**SECTION 00 90 03
BIDDING AND CONTRACT REQUIREMENTS
ADDENDUM NUMBER 3**

Re: ADDENDUM NUMBER (3) TO THE BIDDING DOCUMENTS FOR

**McHenry County College
University Center at MCC**
Architect's Project Number: 22-050

SHEET NUMBER:
ED1.10

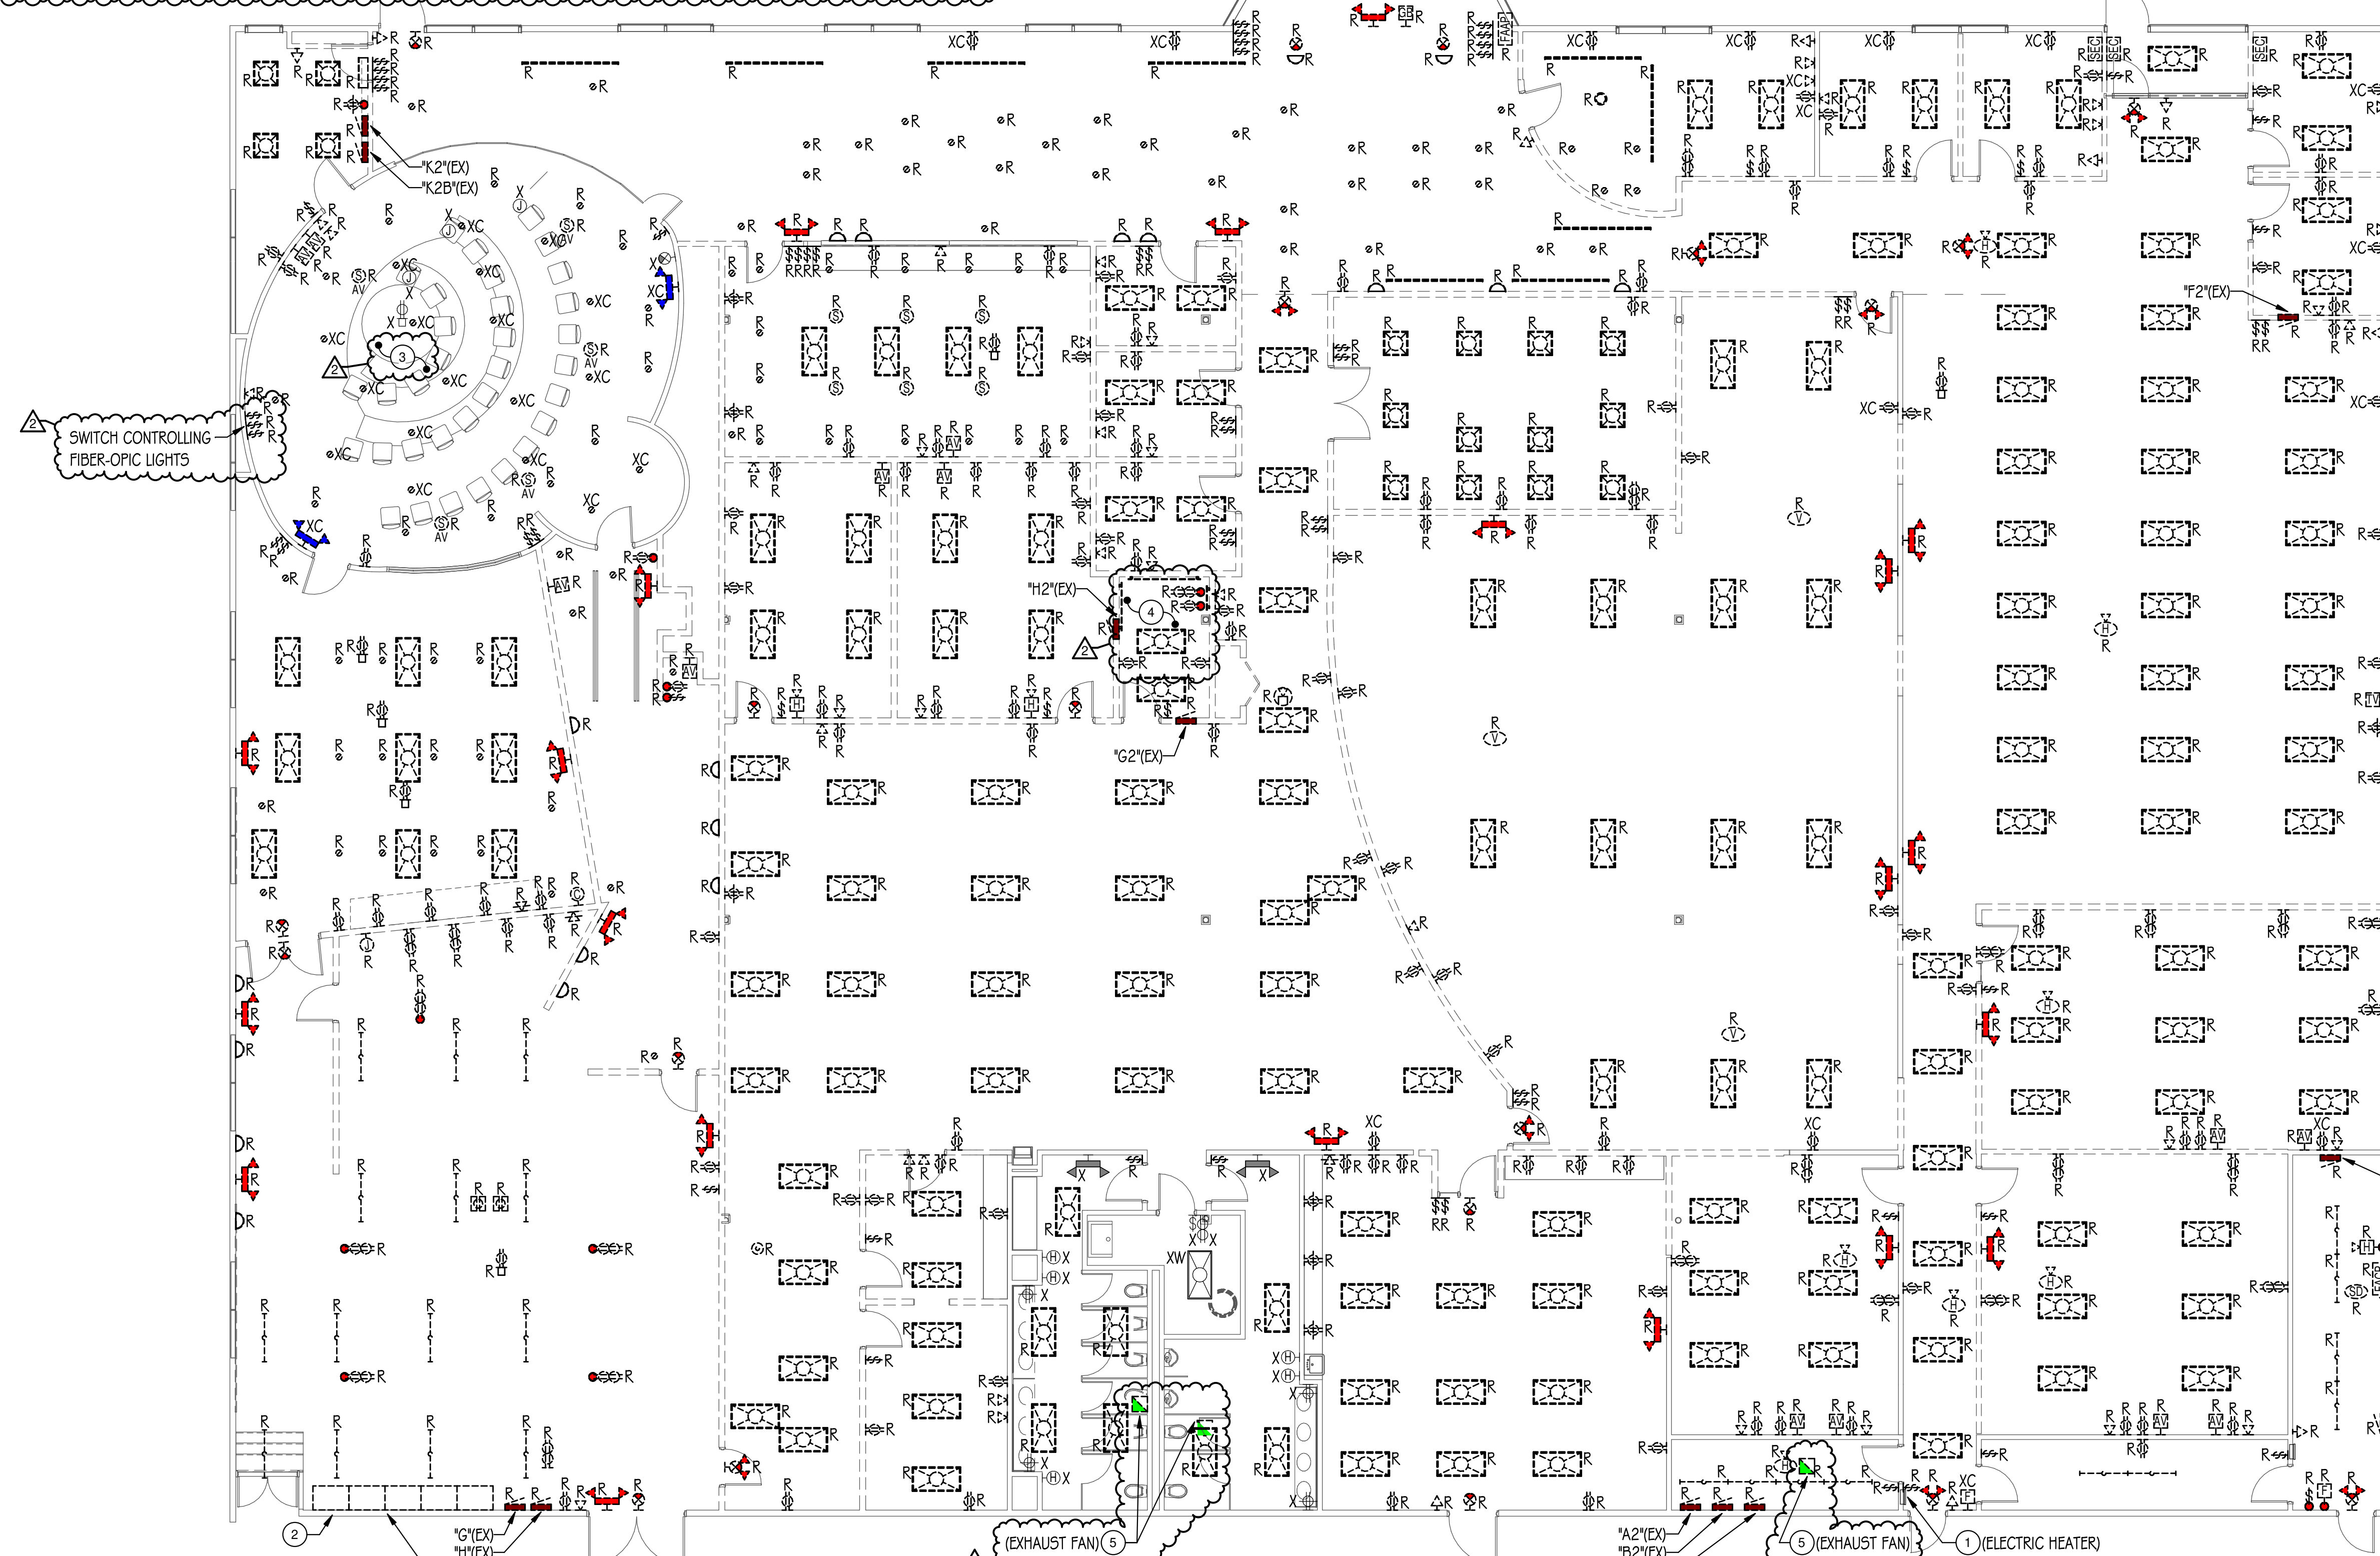
1. ED1.10
 - A. **ADD** note to disconnect existing mechanical equipment in restrooms and storage room.
 - B. **ADD** note to keep existing fiber-optic lights in round classroom.

- C. **ADD** note to relocate existing telecommunication service in existing IT room.
 - D. **ADD** photo of existing IT room.
2. E1.10
 - A. **REVISE** locations of exterior and interior security cameras.

SHEET NUMBER:
E1.10

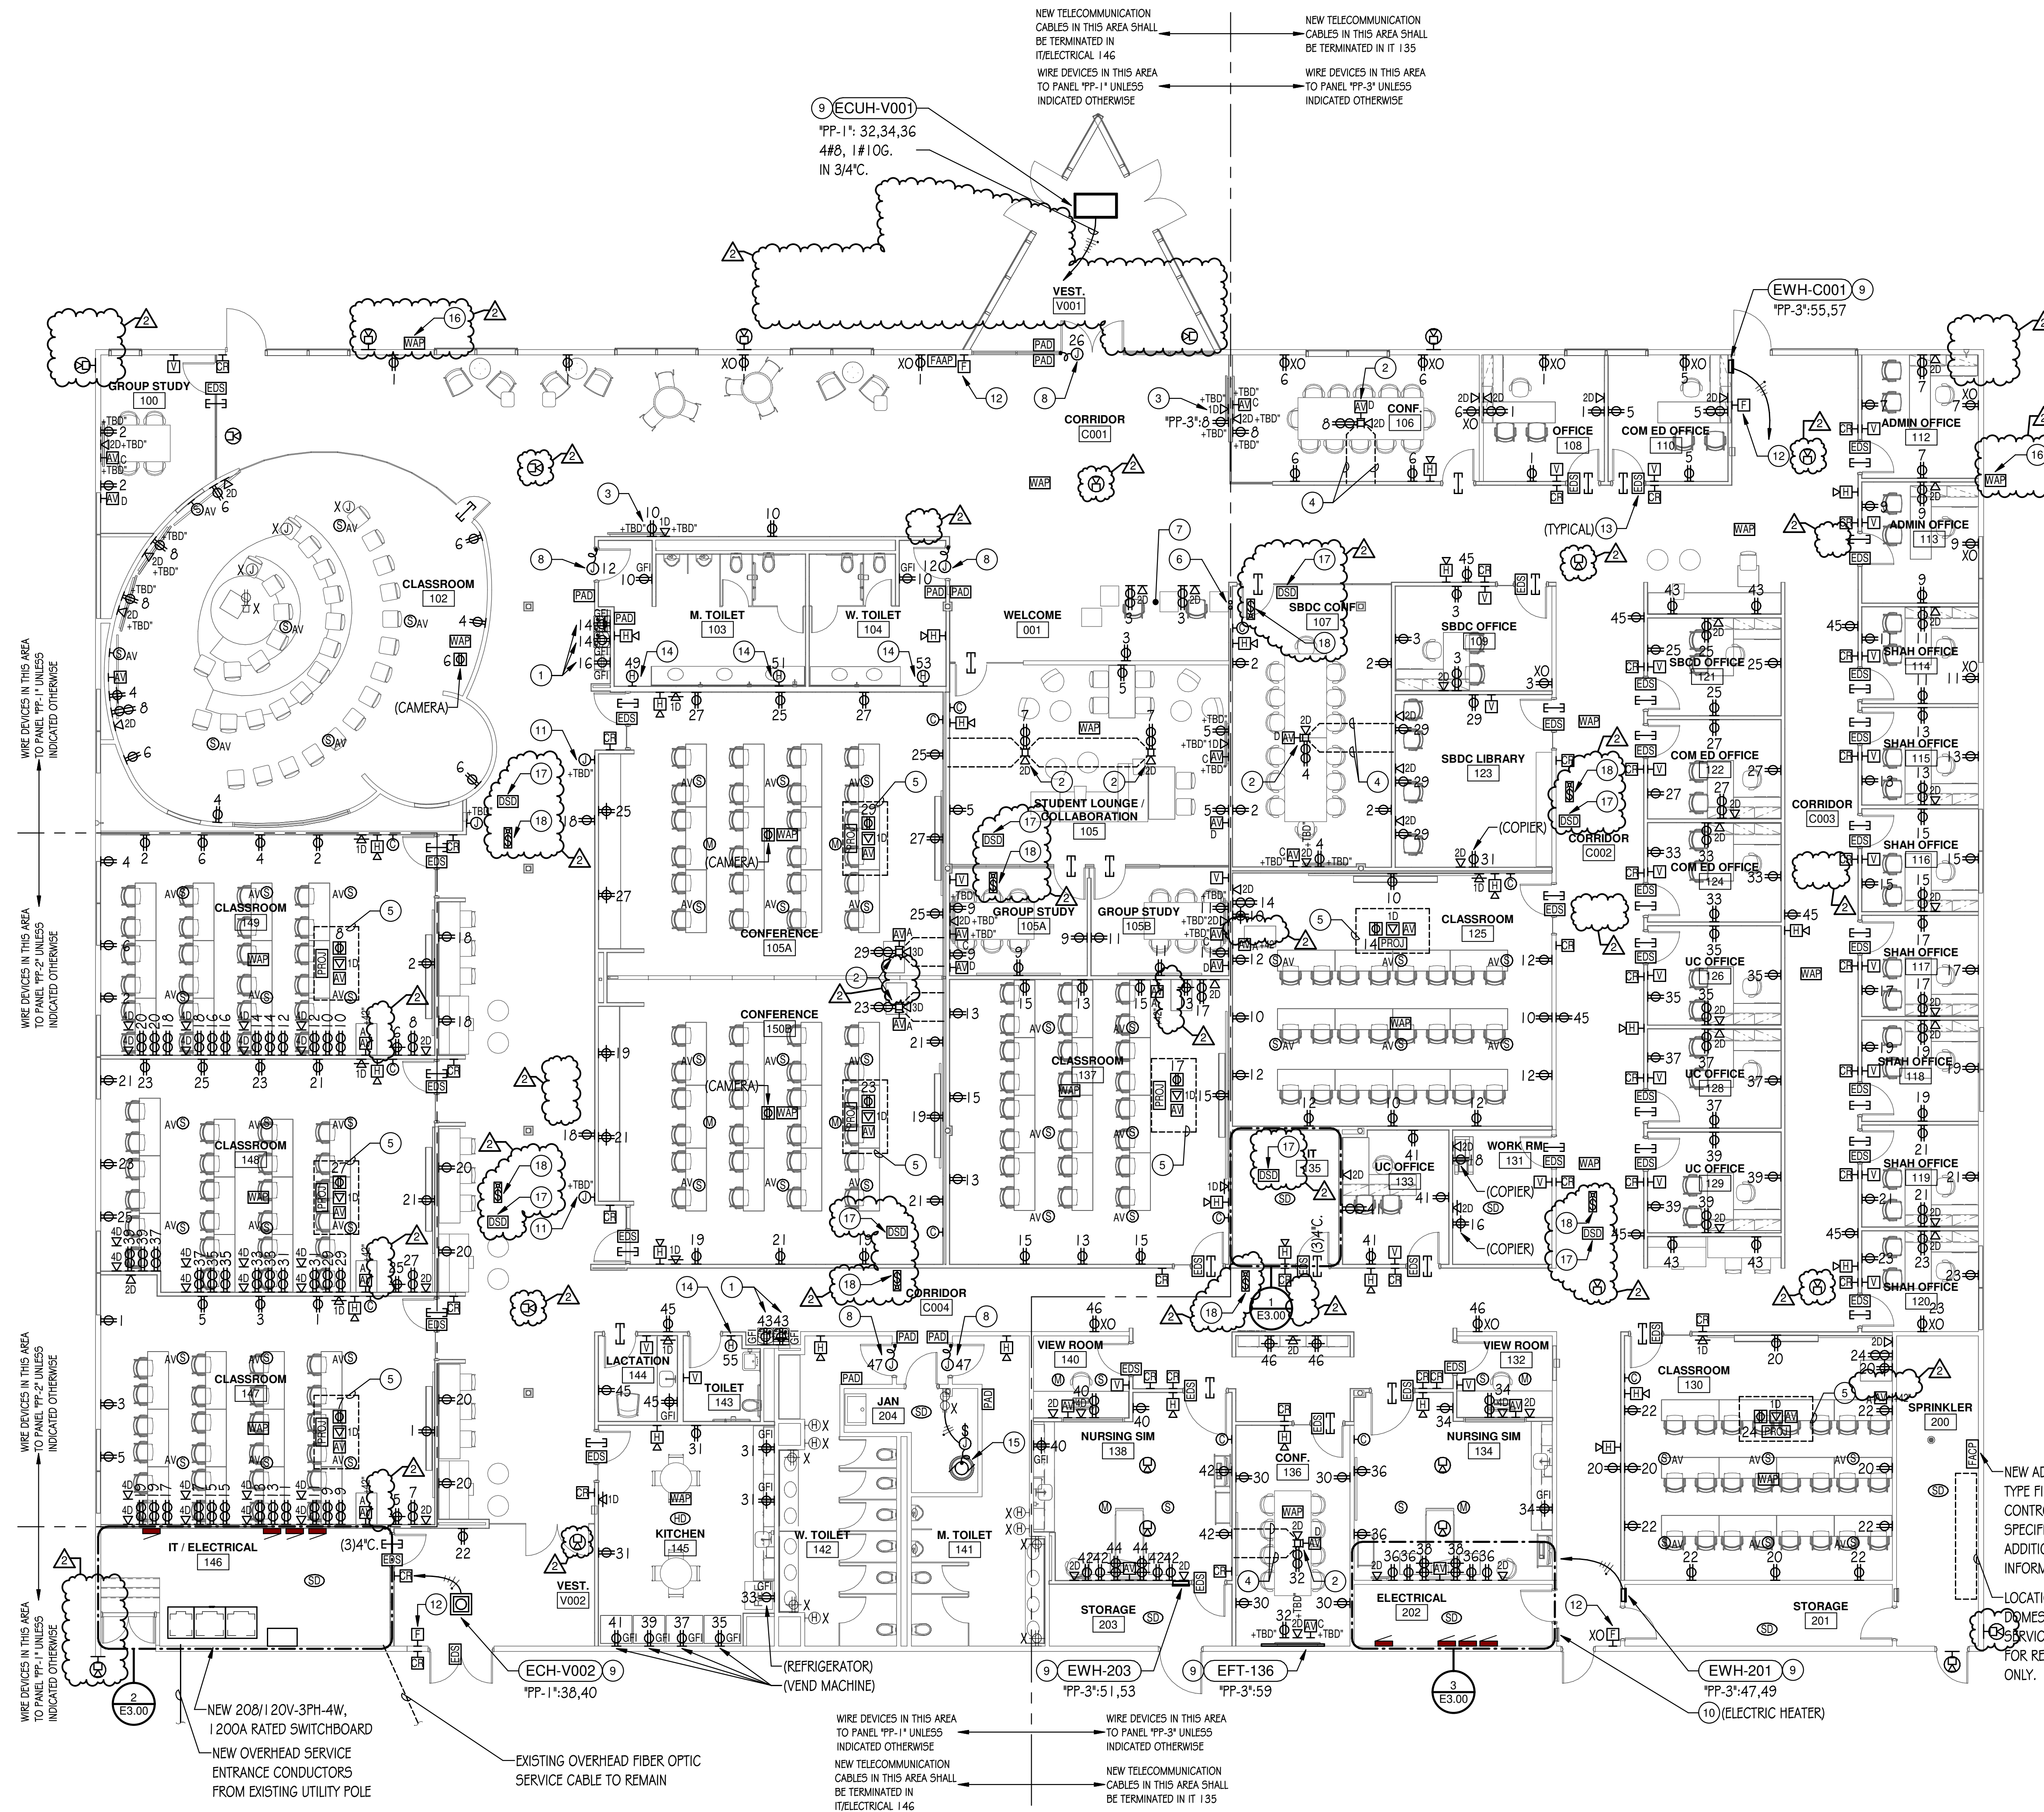
- B. **ADD** locations of exterior wireless access points.
 - C. **DELETE** work door operator and card reader work in Vestibule V001.
 - D. **ADD** locations of duct smoke detectors and associated test switches.

- E. **DELETE** locations of 'AV-B' devices.
3. E2.10
 - A. **REVISE** switchleg designation in Classroom 102.
 - B. **ADD** note to keep existing fiber-optic lighting in Classroom 102.

SHEET NUMBER:
E2.10

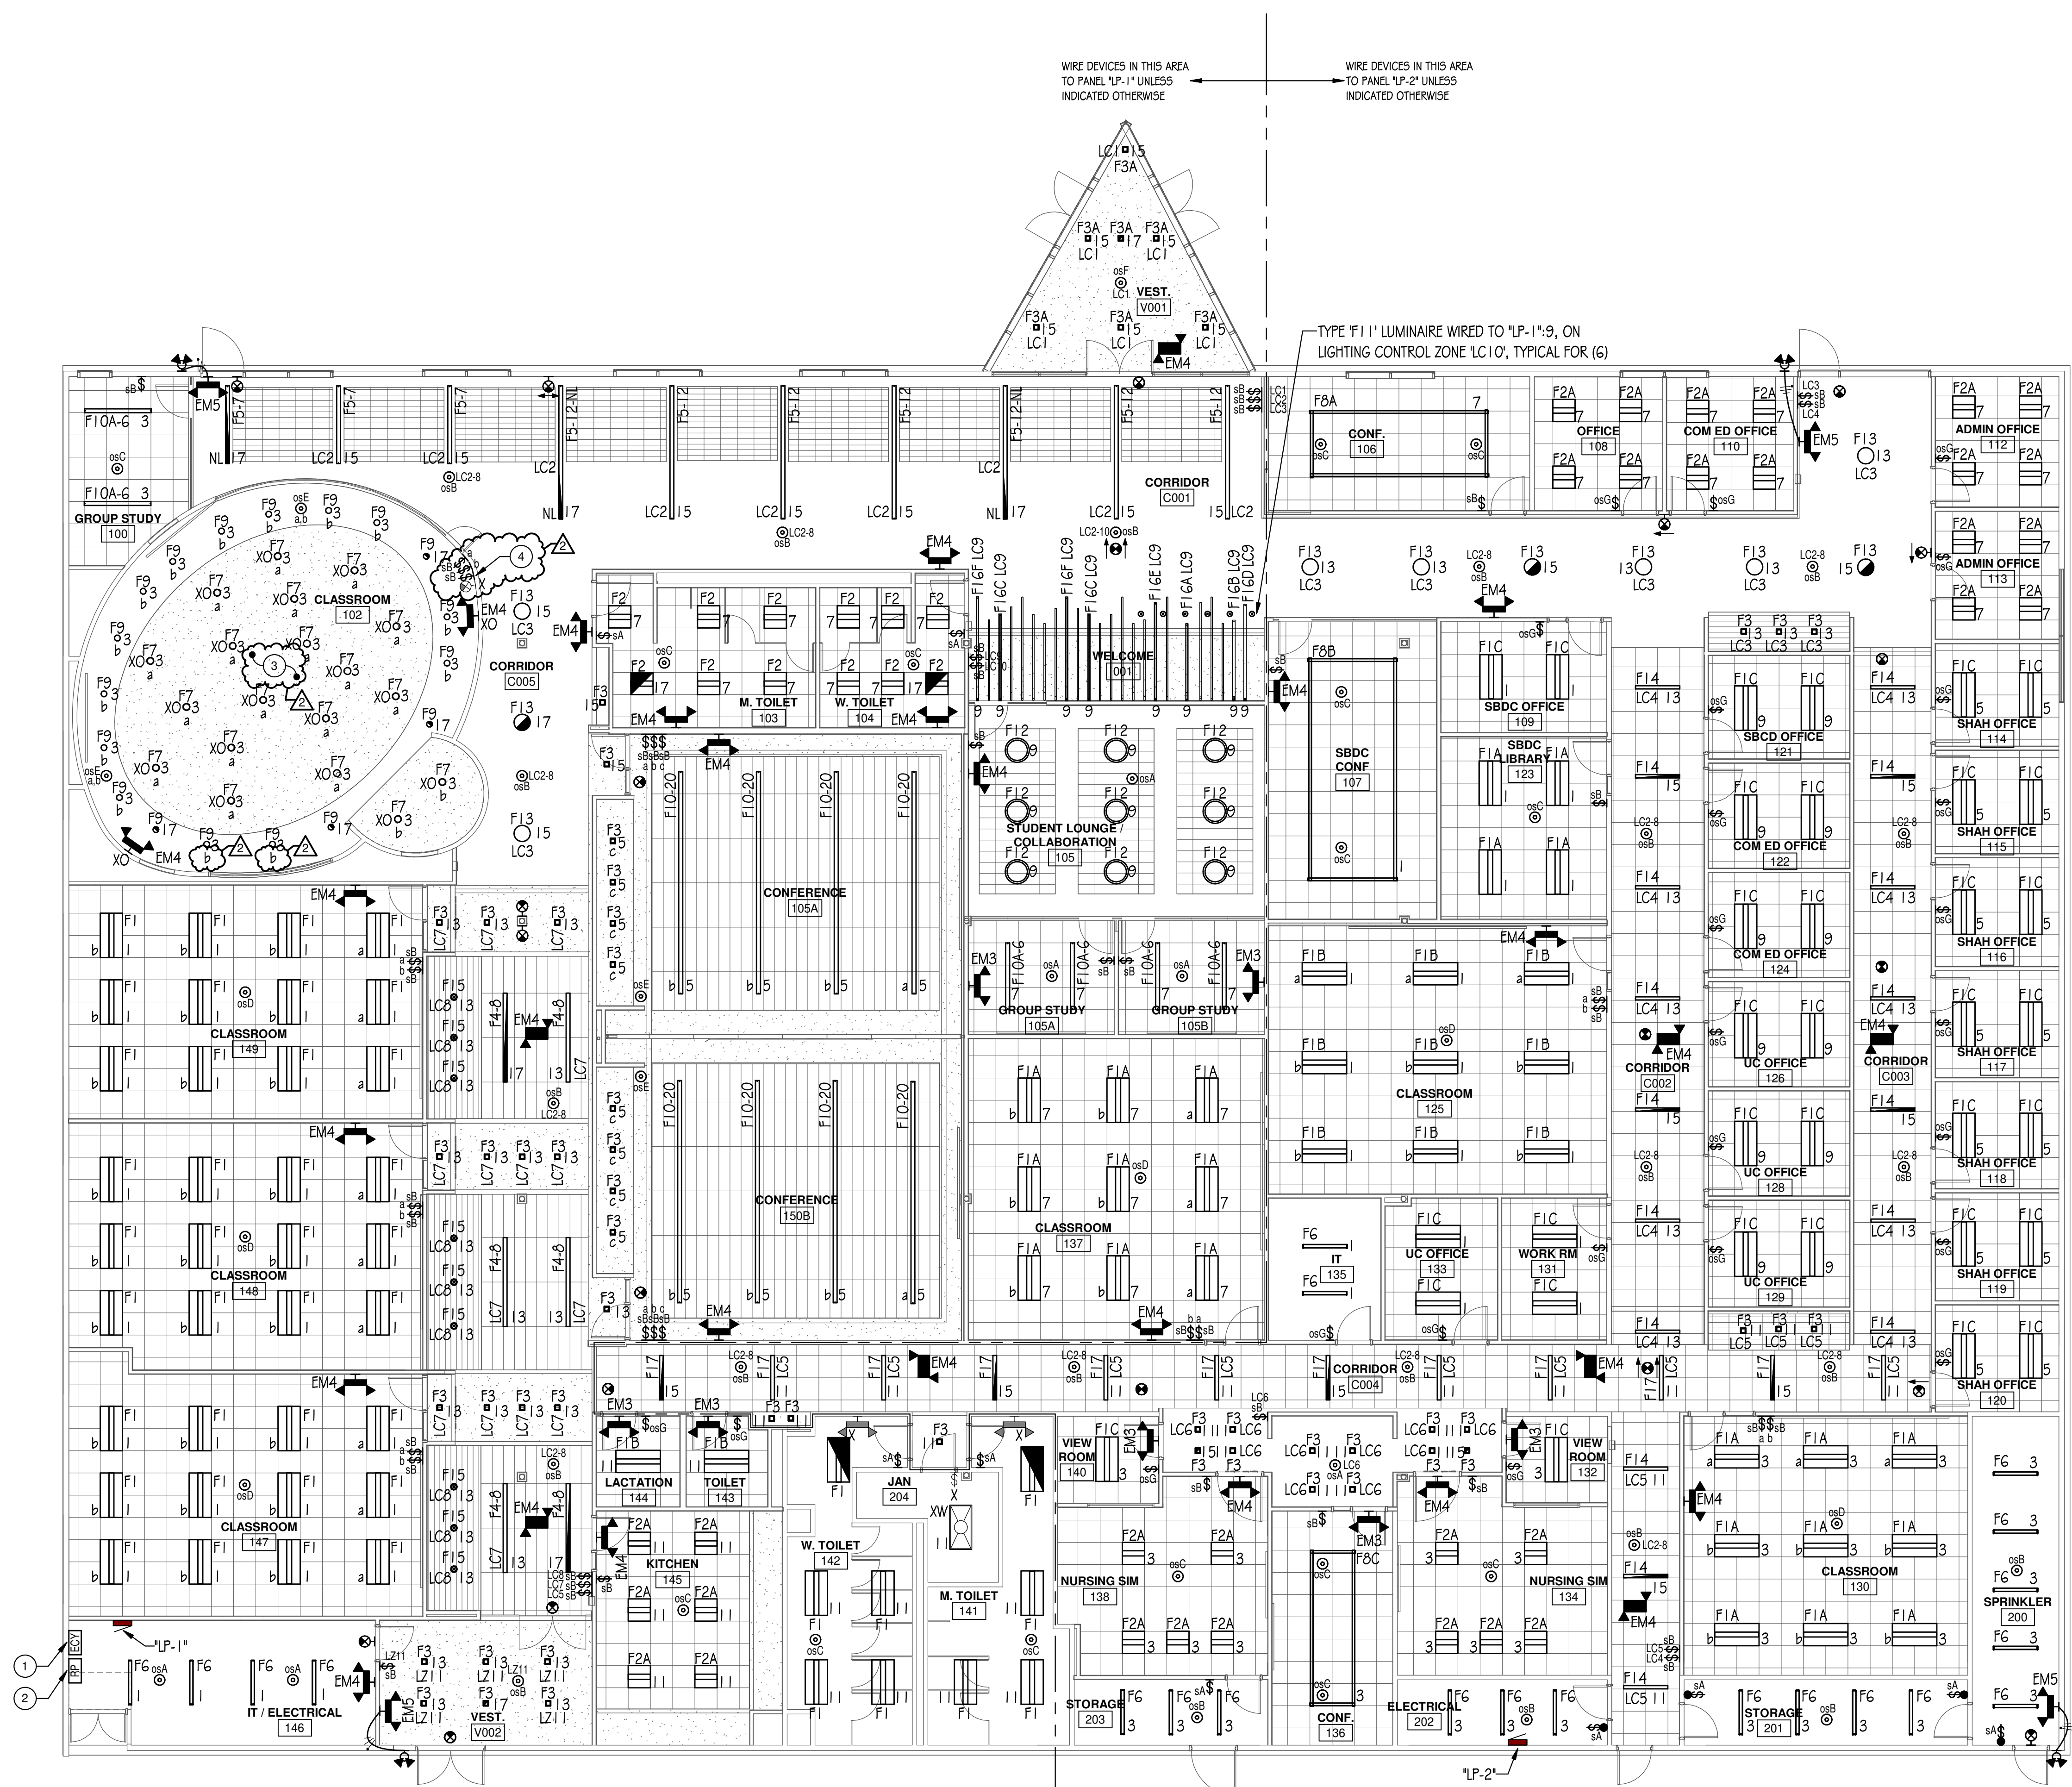
- C. **ADD** switch to control existing fiber-optic lighting in Classroom 102.
4. E3.00
 - A. **ADD** note to show new location of telecommunication equipment in IT / Electrical 146.
